Item Name: Crosstube Turning Detail

| DE APPR. | RF | CROSSTUBE (205/212 LOW AFT) | NTS |

| DRAWING NO. D212-664-247 | TITLE CROSSTUBE ASS'Y (205 LOW AFT) | REV. B | DART AEROSPACE LTD ENGINEERING ORDER | | D.E.O. NO. D212-664-247-B-1 | SHEET NO. SHEET 1 OF 1 | SCALE NTS |

REPLACE MAGNOBOND WITH PROSEAL.

| MFG. APPR. | RF | D212-664-247 | SHEET 1 OF 4 |

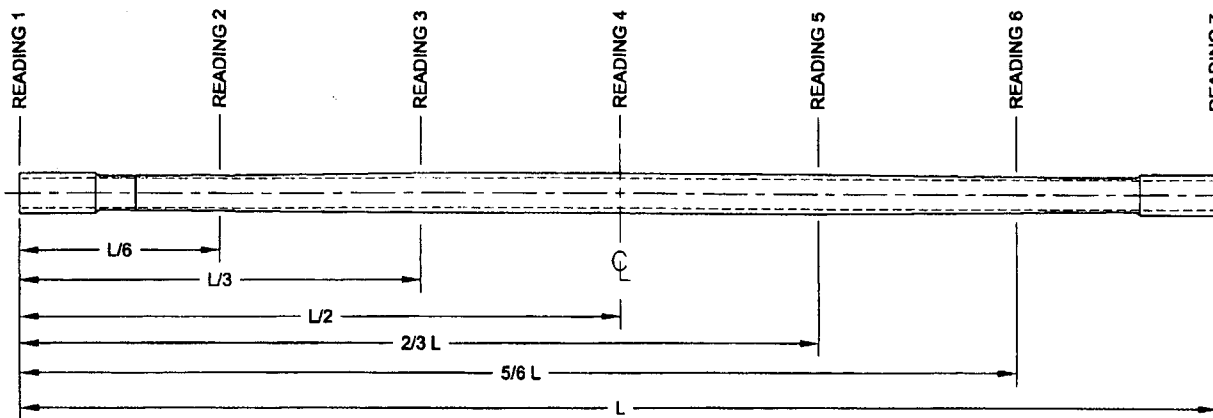
NOTE 12 & 15, SHEET 1 IS AMENDED AS FOLLOWS:

| Item | Qty -247 | Qty -247B | Part Number | Description |
| 9 | A/R | A/R | PROSEAL 890 B-2 | SEALANT, AMS-S-8802 CLASS B-2 |

12) TO INSTALL D2940-1 SUPPORT: ABRASE MATING SURFACE OF SUPPORT AND CROSSTUBE WITH 180-GRIT SANDPAPER AND REMOVE RESIDUE WITH MEK (OR EQUIVALENT). APPLY A 0.04" TO 0.07" THICK LAYER OF PROSEAL 890 CLASS B-2 (OR AMS-S-8802 CLASS B-2) SEALANT TO MATING SURFACE OF SUPPORT.

15) TORQUE CLAMPS 80 TO 100 IN-LB. ENSURE AT LEAST 1.5 THREADS SHOWING IN SAFETY AND THAT NUT HAS NOT BOTTOMED-OUT AFTER TORQUING. **PRIOR TO PACKAGING, RE-CHECK TORQUE ON CLAMPS AFTER PROSEAL 890 SEALANT HAS CURED FOR 72 HOURS.**
